ENVIRONMENTAL MINOR PROJECT CHANGE FORMProject Name: Banducci Substation Request Prepared By: TRCDate Approval Required: 3/20/2018 Variance Request No: Minor Project Change No. 5Date Submitted: 3/6/18 Location: Banducci Substation Site (Pellisier Rd. and Dale Rd.)Landowner: Southern California Edison & R&R Properties LLCLandowner Parcel Number: 448-052-12 & 448-052-41Current Vegetative Cover/Land Use: Bare ground: un-vegetated areas and dirt roadsExisting Sensitive Resource? No Yes Specify: _____

Minor Project Change Description, Justification, and Analysis Banducci Substation Project

Minor Project Change Request No. 5

MPC No. 5 Site Plan

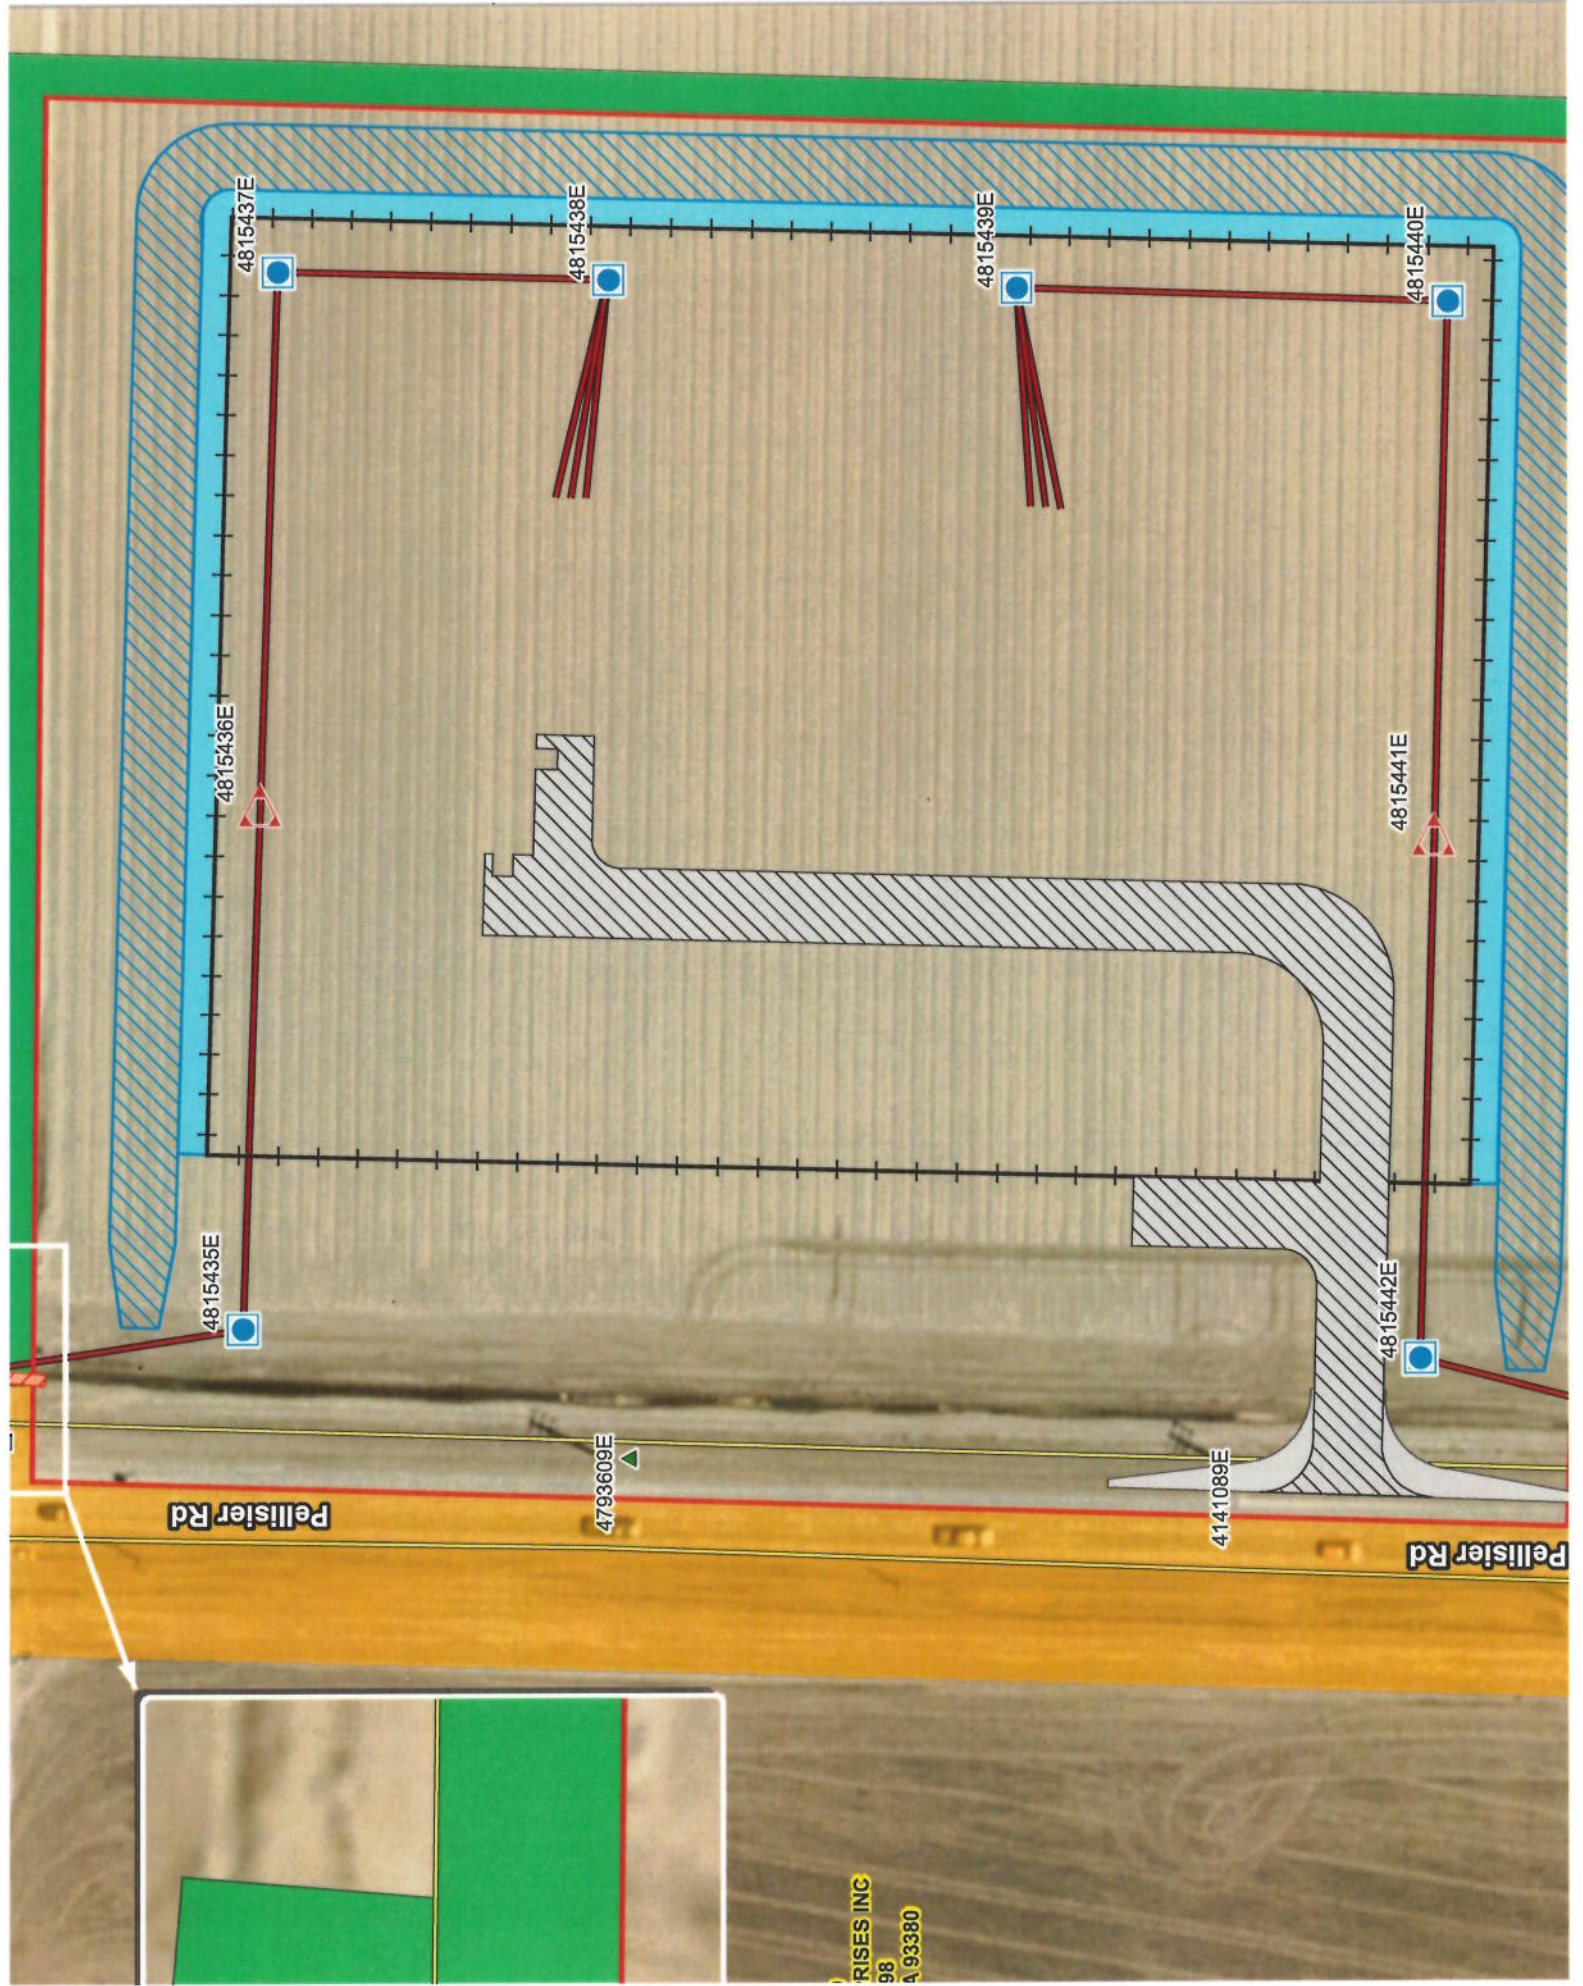
SCE has identified the need for a Minor Project Change (MPC) to the approved Banducci Substation Project (MPC Request No. 5). The MPC Request No. 5 proposes to add 0.58 acre to the Banducci Substation limits of disturbance (LOD) and approximately 23 square feet to the permanent substation footprint. In addition, three design details are addressed that affect the project GIS database.

1. Final grade smoothing and landscaping along the northern, eastern, and southern parcel boundaries of the Banducci Substation site. This work will include grading and smoothing of the areas between the perimeter ditch/swale and the parcel boundary, and blending the parcel boundary contours with the adjacent ground surface. Approved limits of grading extend to the substation parcel boundary and landscape plantings extend very close to the eastern parcel boundary. Grading and blending at the parcel boundary and landscaping near the eastern parcel boundary cannot be practically accomplished without equipment traffic extending over the property line. Approximately fifteen feet of temporary access for construction workers and equipment will be needed beyond the eastern and southern borders of the approved LOD/parcel boundary to practically complete planned work (refer to Attachment A, MPC No. 5 Site Plan). This 15 feet is comprised of an existing agricultural road that was developed after grading at Banducci substation was completed (refer to Attachment B, MPC No. 5 Photo Log). Along the northern border of the approved LOD, MPC No. 5 would increase temporary construction access by approximately 20 feet, which represents the portion of the existing unpaved farm road (Dale Road) within SCE's land parcel (APN 448-052-12). All of this expanded LOD area is under SCE ownership.

2. Replacement of the culvert under an unpaved, private farm road at the north edge of the substation property. The original project design accounted for this culvert to be replaced but the previously permitted LOD did not extend wide enough at this location to include the culvert (refer to Attachment A, MPC No. 5 Site Plan). The northernmost end of this culvert and work area required for installation of this culvert occurs on parcel 448-052-41 located to the north of SCE's property. SCE has landowner permission for the access and installation of the culvert. This change is needed to accomplish culvert replacement.

- Coordinates of the culvert replacement beneath Dale Road require updating. The existing culvert to be replaced is now known to extend approximately four feet farther to the north than depicted in the GIS database submitted with NTP 1. This additional four feet represents an increase to the permanent footprint of approximately 6 square feet.
- To issue the Encroachment Permit for the Substation driveway, Kern County requires SCE to change the substation driveway approach, widening the radius from 18 to 25 feet (refer to

Attachment A, MPC No. 5 Site Plan). This change will require approximately 17 square feet of additional permanent impact area.

- The location of a shotcrete apron installed between the substation perimeter wall and the perimeter concrete swale has been added to the database. This was part of the original design but was not included in the GIS database submitted with NTP 1.

The subject LOD for this MPC is immediately surrounding the previously approved LOD for the Banducci Substation. Specifically, the MPC 5 LOD areas are located along the northern, eastern, and southern borders of the substation site, and near the intersection of Dale Road and Pellisier Road, where the culvert will be replaced. Refer to Attachment A: MPC No. 5 Site Plan for locations of the proposed changes.
